# Slider Module

## Change Notice

**SURE GRIP**  
CONTROLS INC.

Our existing Slider Module has been updated to provide operational and cosmetic improvements:

### Wiring.

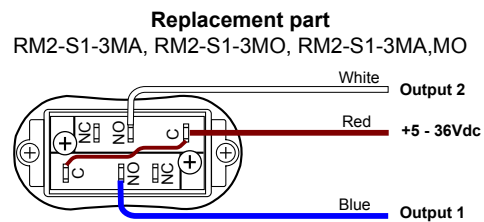
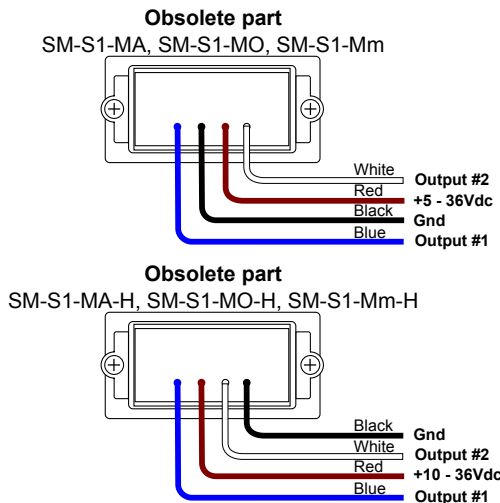
#### - Switched.

-The black wire is not required in the replacement configuration and should be cut from the old part with some heat shrink placed over the bare end.
